## Addendum No. 1

Date: July 29, 2015  
To: Design/Build Teams  
From: Bianca Shama – Project Manager  
Reference: Ground-Mounted Solar Photovoltaic Facility- Davis Campus  
Weber State University- Layton, Utah  
DFCM Project No. 15279810

# WEBER STATE UNIVERSITY - DAVIS

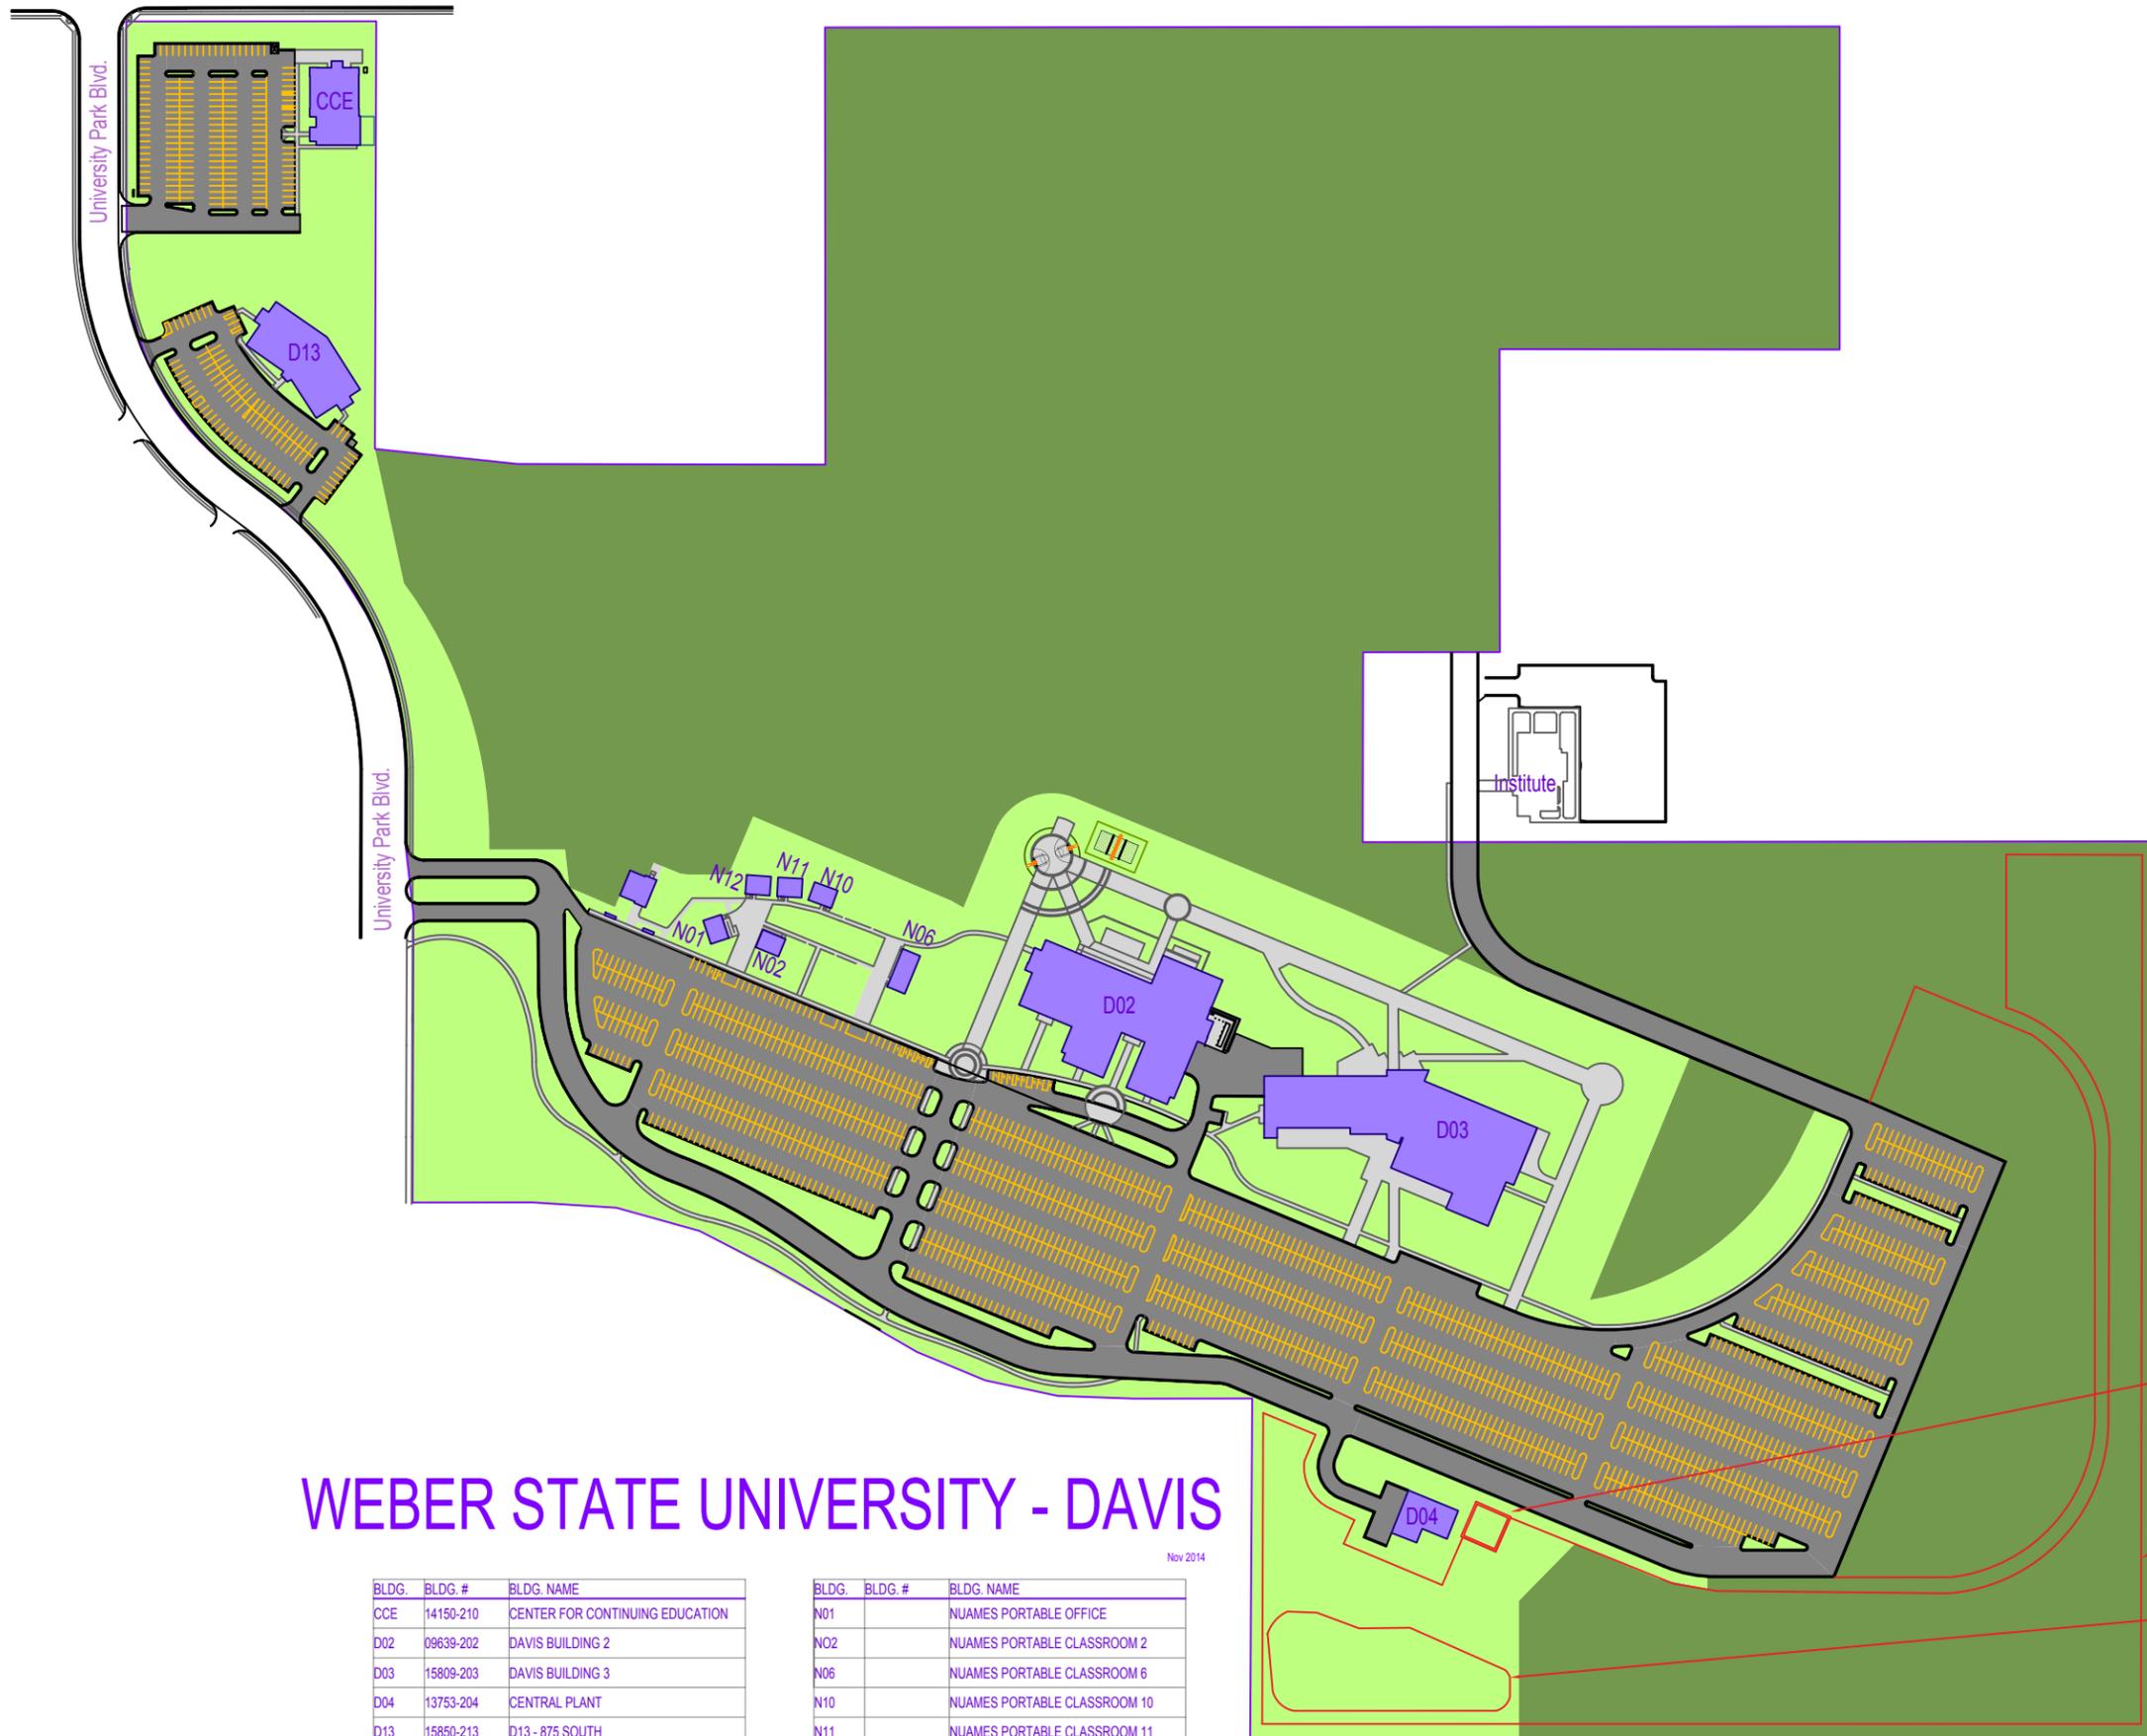
- 1.2.2.2 Question: There's a flat area and an upslope and downslope. Why Did WSU take out a big chunk of flat area from the proposed site area?  
Answer: The eastern and northern sections that are shown outside of the proposed footprint (shown dashed on our site plan) is designated as a future parking area in our campus master plan.

- 1.2.2.16 Clarification: The existing storm water detention basin on site (just south of the central chiller plant). This space can be used for panels, but if so, the

- 1.2.2.22 Question: Can we get a CAD file to accurately scale off of instead of a PDF?  
Answer: Yes, we can provide a CAD version of the proposed site plan as part of our addendum. This is attached.
